Memorandum

*Subject: Watershed Delineation Rezoning Review – Gravel Pit Parcel
Lake Auburn Watershed Protection Commission*

Figure ES-1: Summary of Estimated Watershed Boundary Review

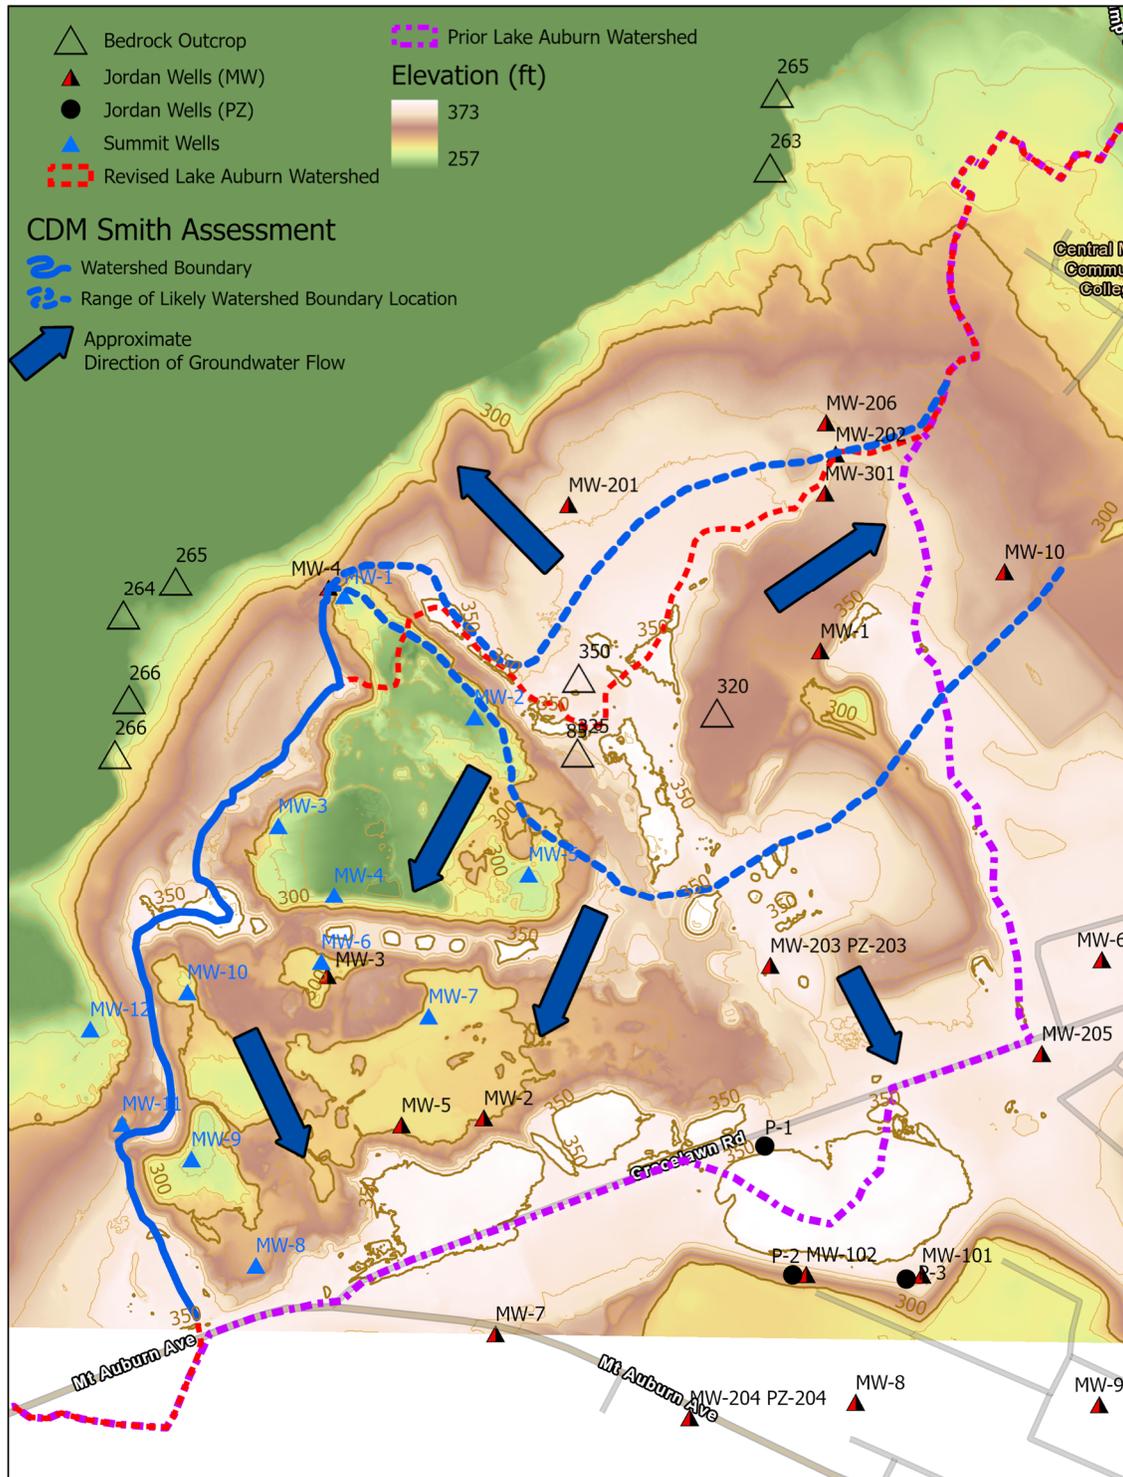
Based on CDM Smith's review, the groundwater data support the revised watershed delineation in some areas, and in other areas the data are insufficient to confirm a precise delineation. **Figure ES-1** presents a summary of the review, including the revised delineation (red dashed line), the area of uncertainty (blue dashed line) and direction of groundwater flow (blue arrows), and can be summarized as follows:

- The solid blue line to the west is a delineation that reflects surface topography and is consistent with the FB Environmental revised delineation except for a small area to the north near MW-1 and MW-4. To the south of this line, data from 14 groundwater monitoring wells indicate flow in the surficial sand and gravel away from the lake and, significantly, groundwater levels that are below lake level, precluding discharge to the lake.
- Near the center of **Figure ES-1** are three triangles indicating the location and elevation of bedrock outcrops. In this area of high bedrock (so called "bedrock knob"), the water table is

in bedrock and is above lake level based on surrounding well data. However, in the reviewed reports there is no well data to indicate bedrock flow direction in this area. Hence, **Figure ES-1** indicates a band of uncertainty in the area of the outcrops and nearby topographic high elevations.

- To the east of the bedrock knob, water level data from wells MW-1, MW-10, MW-301 and MW-206 indicate a water table in the sand and gravel above lake level with a generally northeastward flow direction. Groundwater within the band of uncertainty in this area could possibly discharge to Lake Auburn or to a stream farther to the east that is tributary to the Androscoggin River.
- The northern limit of the uncertainty band in **Figure ES-1** is approximately consistent with a surface drainage divide indicated by topography. To the south of the uncertainty band, water level data (and also water quality data) indicate that the water table is in the surficial sand and gravel with a flow direction away from the lake. This includes data from wells MW/PZ-203, P-1, MW-205, MW-102/P-2 and MW-101/P-3.

To determine the limit of the watershed in this “area of uncertainty”, the following steps would be recommended:

- Create a 3-D geometric visualization model and associated geographic information system (GIS). The scope of effort would include:
 - Incorporation and integration all of the relevant geologic, well construction, water level and water quality data included in the reports that were reviewed.

- Based on the visualization model, the need for and focus of additional field data collection and/or groundwater flow modeling can be assessed. While it is likely that additional field exploration, including installation of new monitoring wells, will be required to more precisely delineate the watershed, preliminary visualization and modeling analysis can make this investigation more efficient.

Figure 1 Previous (black dashed) and revised (blue) watershed delineation per FP Environmental (2021)

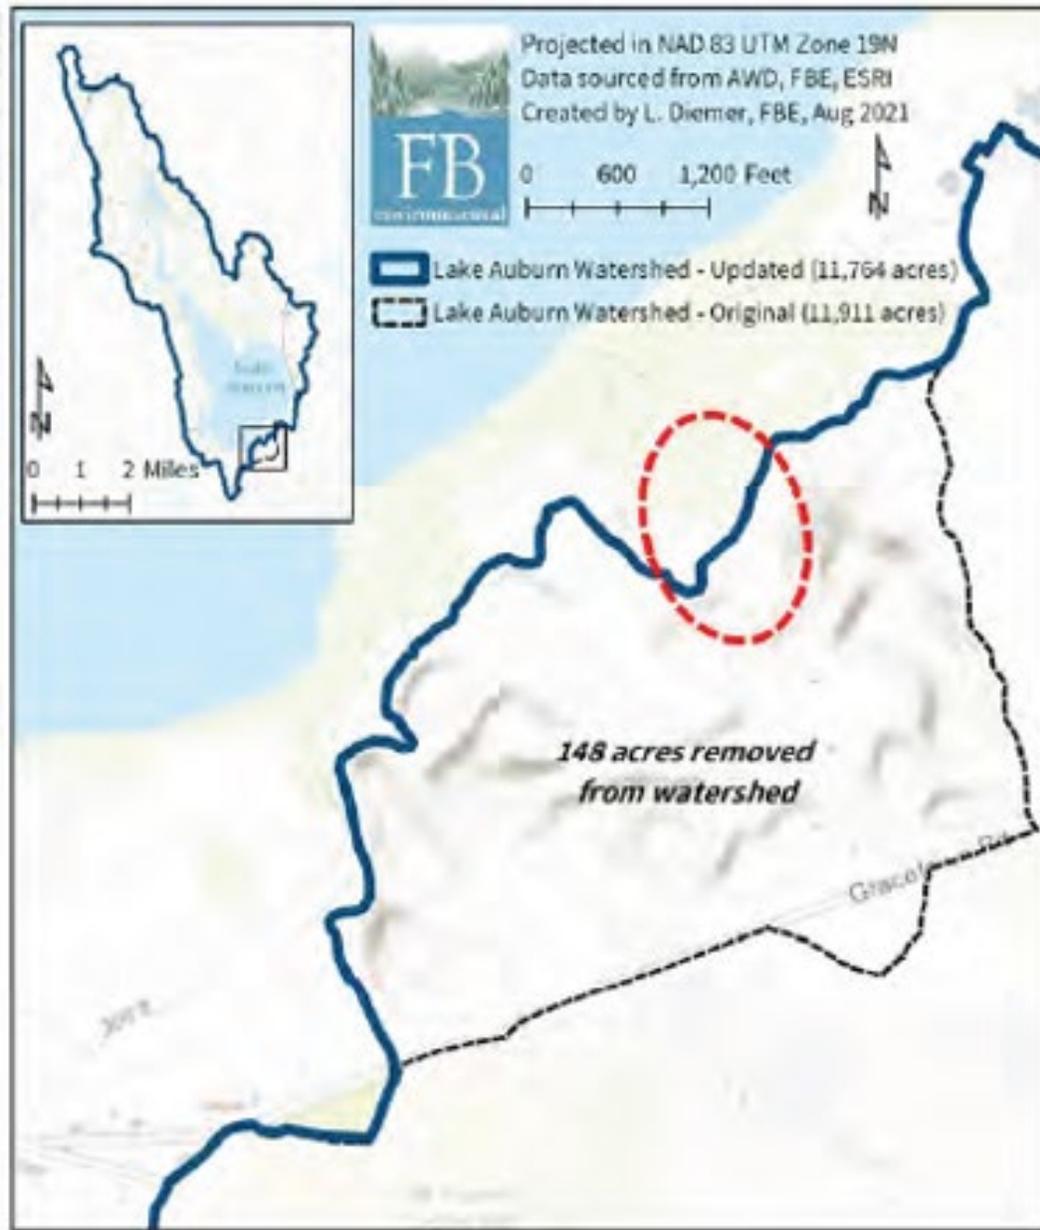
The watershed delineation was moved northward, closer to the lake, removing approximately 148 acres from the estimated watershed. **Figure 1** shows the previous and revised delineations as presented by FB Environmental. **Figure 2** shows an approximation of these delineations sketched onto an aerial photo. The area between the old and proposed new delineations includes a number of sand and gravel borrow areas on the west side and former City of Auburn landfill and dump areas to the southeast

As part of an environmental and regulatory analysis of Lake Auburn water supply protection (FB Environmental, 2021), a revised watershed delineation of the watershed near the southeast shore of the lake was presented which reduced the watershed area by 148 acres (**Figure 1**).

Figure 5 Bedrock surface contour map from E.C. Jordan (1990)

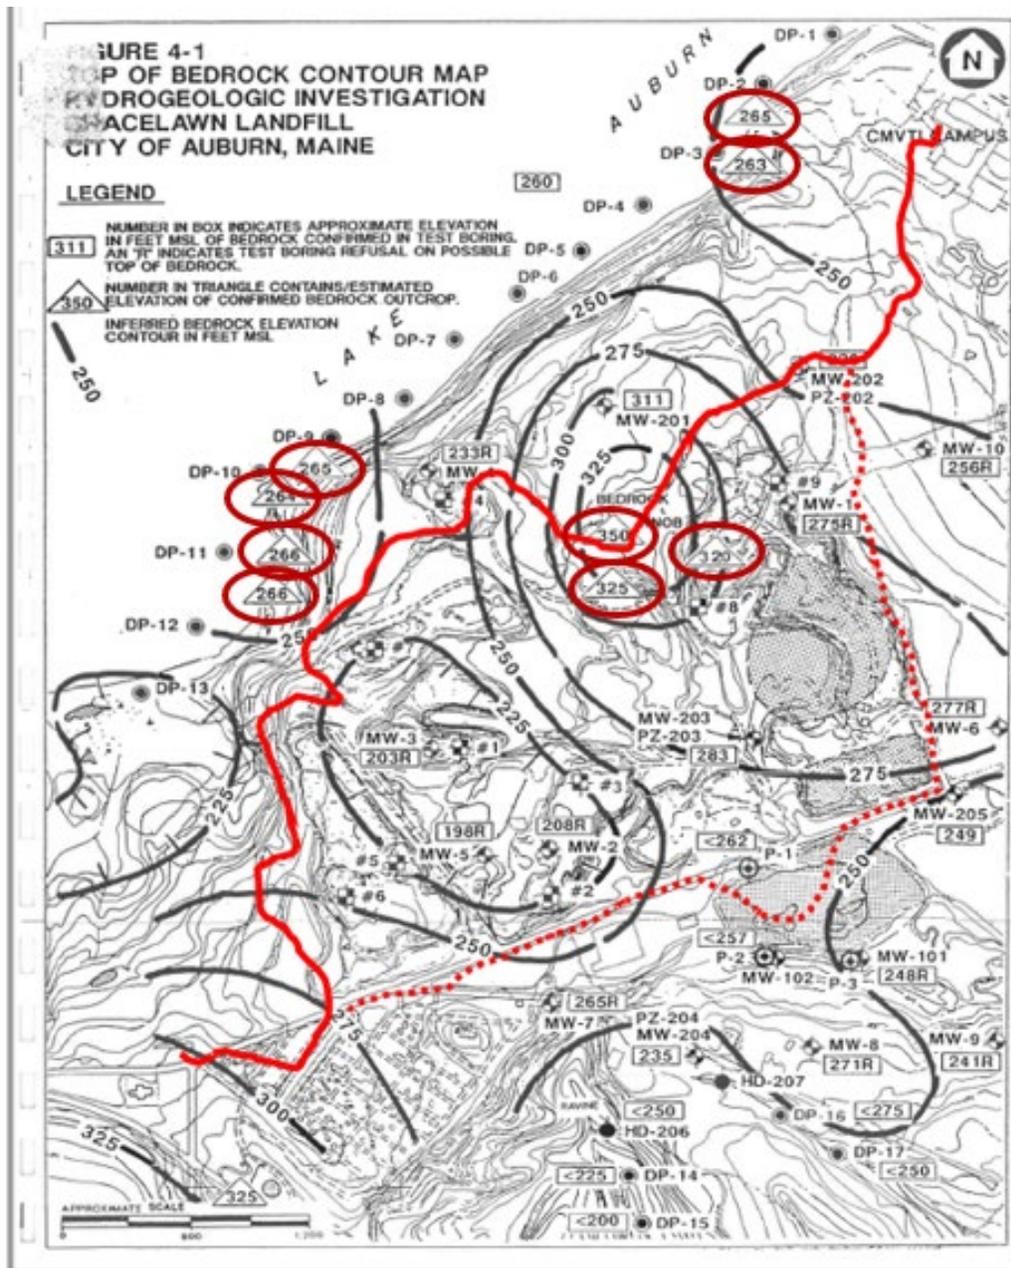
- Near the center of the study area is an area of high bedrock, labeled “bedrock knob” in **Figure 5**. The area includes outcrops, indicated by triangles in the original figure, circled in red in **Figure 5**. Outcrop surface elevations of 350, 325 and 320 feet mean sea level (MSL) are shown. The reported bedrock surface at MW-201, just north of the outcrops, is also greater than 300 feet.
- The bedrock surface appears to decline most steeply from the “knob” area to the north and northwest towards the lake, and to the southwest.

Figure 6 Bedrock surface contours from Woodward & Curran (1995)

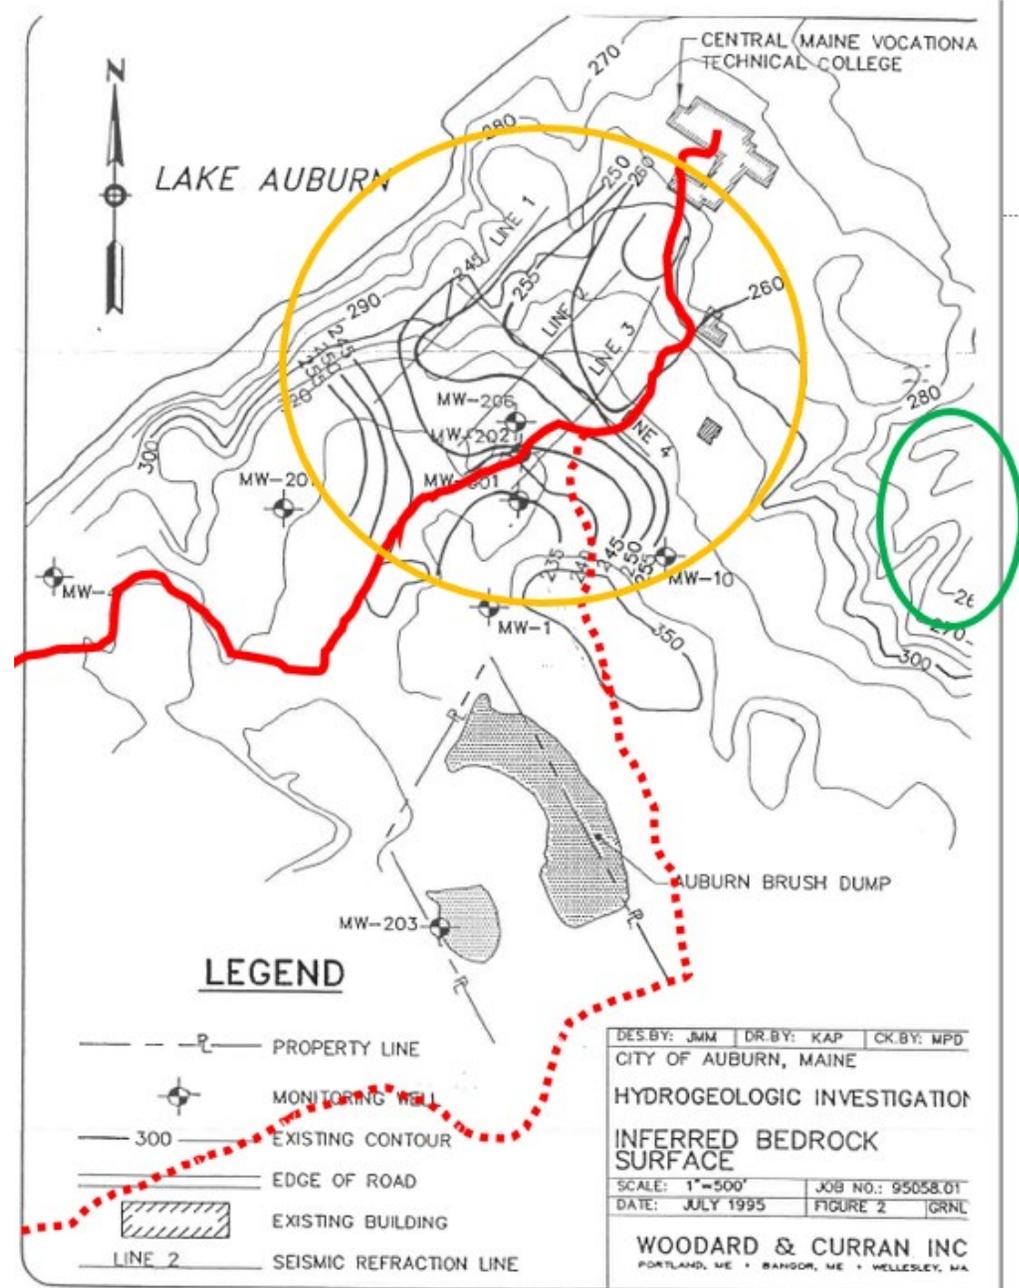
- **Figure 6** shows bedrock surface elevation contours for this area presented by Woodard and Curran (1995). These are based on boring logs and the seismic survey. The contours indicate the bedrock surface is lower than 250 (and as low as 235) feet MSL at MW-202, MW-206 and MW-301, approximately 900 feet east of the knob, indicating a significant decline.
- The contours indicate a subsequent rise in the bedrock surface to elevations greater than 260 feet MSL farther to the northeast.

- Note that the contouring shown in **Figure 6** does not account for the higher bedrock surface estimated at MW-1, approximately 500 feet south of MW-301, to be 275 feet MSL.
- The green circle at the eastern edge of **Figure 6** highlights locations where the topographic contours indicate areas where the ground surface is less than 260 feet. The area is highlighted in **Figure 6** because subsequent figures in this report do not extend that far to the east.

Figure 7 Subarea A: Lake Agawam sediment probes

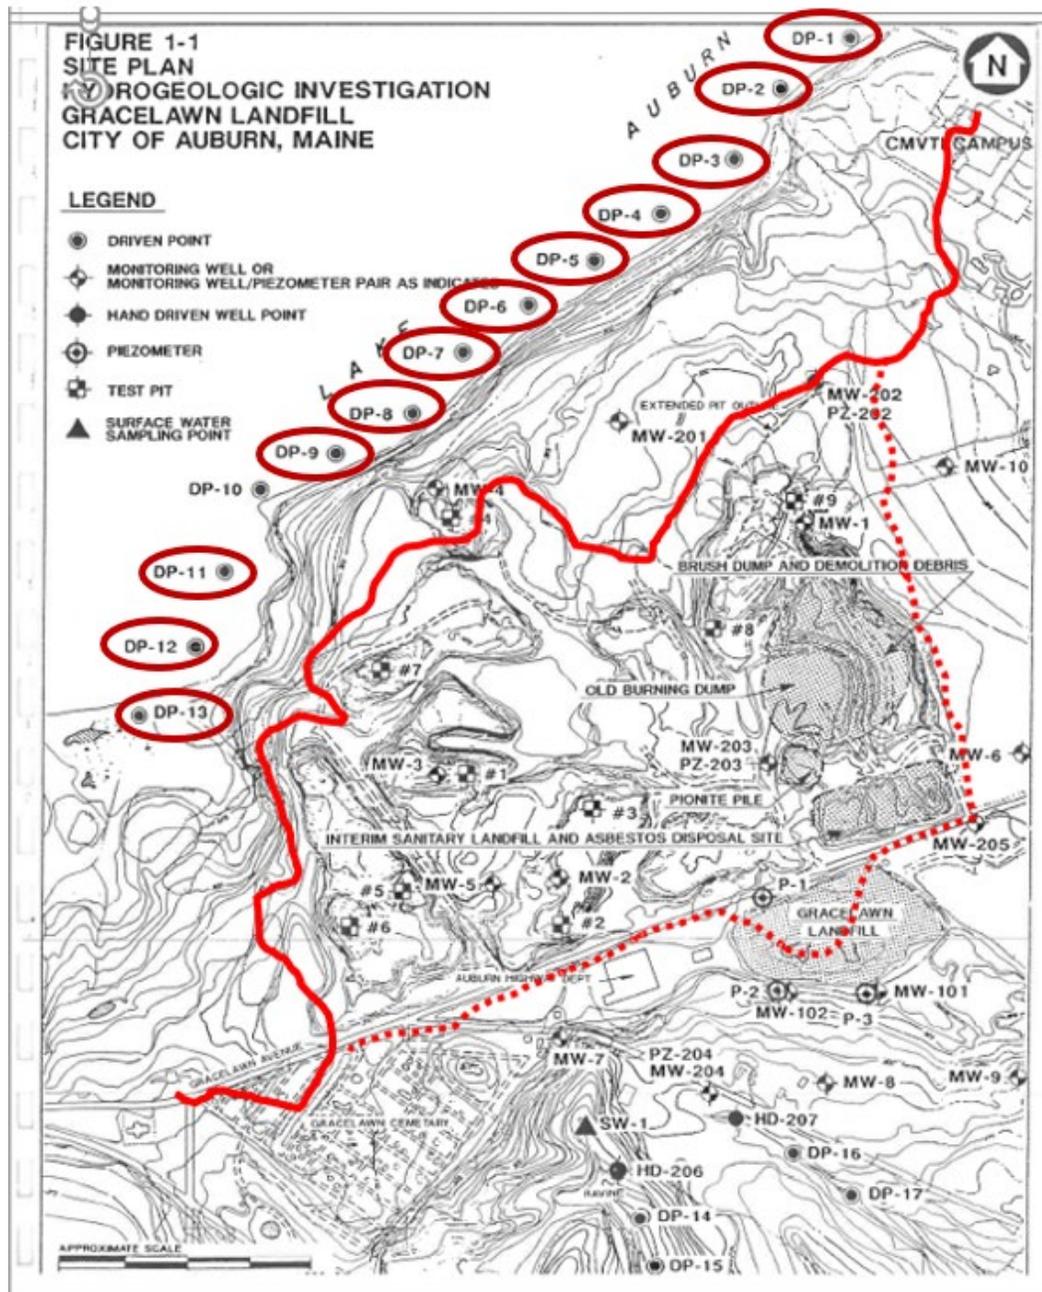
- Groundwater level probes installed 2 to 4 feet into the lake bottom sediments just offshore (**Figure 7**) indicated upward head gradients, i.e., groundwater flow into the lake, at 10 of the 12 working probes. (DP-10 was damaged.)

- A slight downward gradient was observed at DP-13 adjacent to the wetlands near the northwestern extent of the study area. DP-2, near the northeastern extent of the study area also indicated a downward gradient.

Figure 10 Subarea D: Gracelawn Landfill monitoring wells and MW/PZ-203

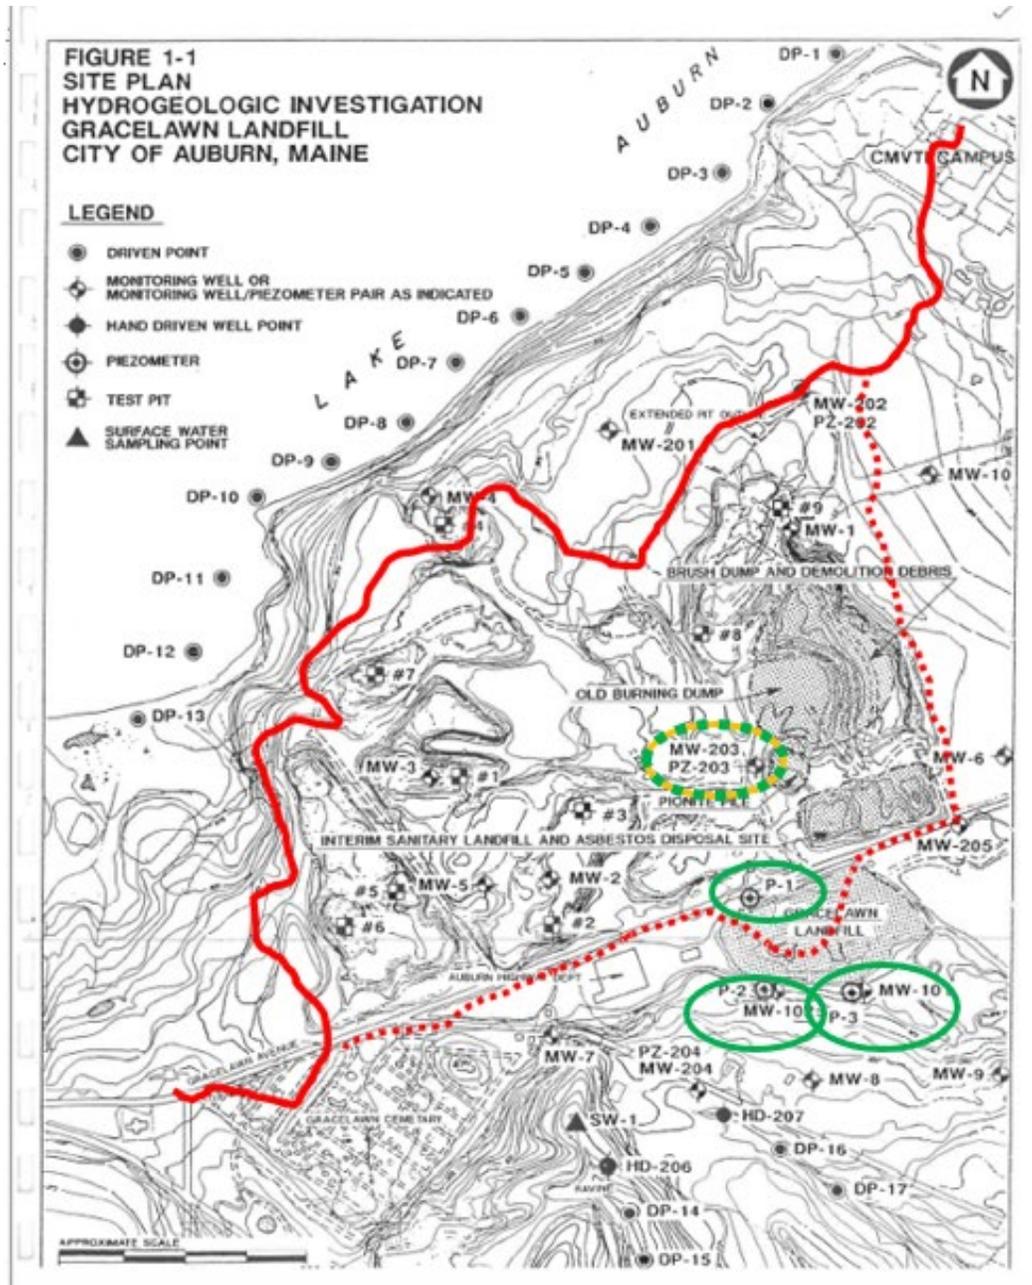
- Southerly flow away from the Lake is indicated in the vicinity of the Gracelawn Landfill by groundwater levels measured at piezometers P-1, to the north, and P-2 and P-3 to the south of the landfill. The piezometer locations are circled in **Figure 10**.

- To the north of the Graceland landfill approximately 600 feet, the water level at PZ-203 (289 to 293) is much higher than the water levels at the nearest wells to the south, southwest and southeast. It is likely, therefore, that groundwater flow from this location (dashed green circle in **Figure 10**) has a southerly component away from the lake, which is nearly one-half mile to the north.
